Project	IEEE 802.16 Broadband Wireless Access Working Group < http://ieee802.org/16 >	
Title	Clarification on UL CQICH SNR feedback for MIMO systems	
Date Submitted	2005-06-02	
Source(s)	Jianzhong (Charlie) Zhang, Anthony Reid, Kiran Kuchi, Heikki Berg, Nico Van Waes Nokia Research Center 6000 Connection Drive Irving, TX 75039	Voice: 972-374-0958 Fax: 972-894-5937 charlie.zhang@nokia.com
Re:	IEEE 802.16e D5 Draft	
Abstract	Proposes an improved channel quality indicator for vertically encoded MIMO systems	
Purpose	To incorporate the changes here proposed into the 802.16e D8 Draft. Crossed-out indicates deleted text , blue indicates new text change to the Standard, and black indicates text in the current version of draft.	
Notice	This document has been prepared to assist IEEE 802.16. It is offered as a basis for discussion and is not binding on the contributing individual(s) or organization(s). The material in this document is subject to change in form and content after further study. The contributor(s) reserve(s) the right to add, amend or withdraw material contained herein.

Clarification on UL CQICH SNR Feedback for MIMO Systems

Figure 229b – Post Processing S/N for MIMO

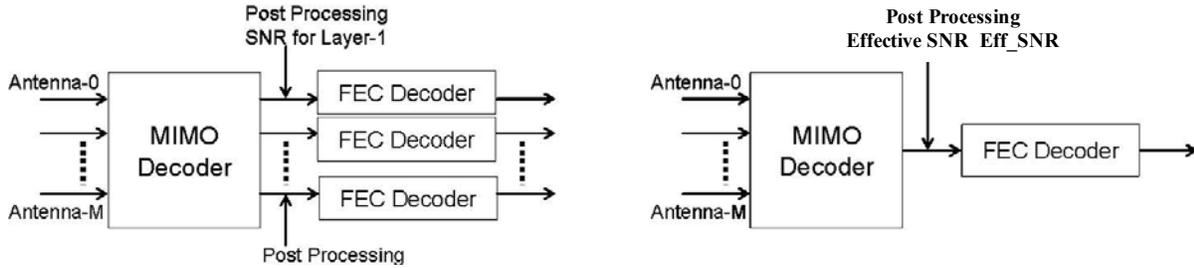
MIMO capable MS shall measure post processing S/N for each individual layers as shown in Figure 229b. When the FAST_FEEDBACK subheader Feedback Type field is “00”, the MS shall report the post processing Effective SNR (Eff_SNR) as defined below. When BS requests MS feedback through CQICH_Alloc_IE() or CQICH_Enhanced_Alloc_IE() with ‘00’ Feedback_type field, MS shall report ~~average S/N~~ Eff_SNR or individual layer S/N as described in 8.4.5.4.12 and 8.4.5.4.15

Note that the effective SNR (Eff_SNR) is defined as

$$\text{Eff_SNR} = e^{C(d,y|H)} - 1 \tag{a}$$

where $C(d,y|H)$ is the receiver-constrained mutual information conditioned on knowing the channel knowledge. Note that d is the transmitted signal, y is the post-processing receive signal and H is the channel matrix between transmit and receive antennas. For example, LMMSE-type of MIMO detectors where individual post-detector-processing signal to noise ratios are given as SNR_1, \dots, SNR_N , then the average receiver-constrained mutual information is given by
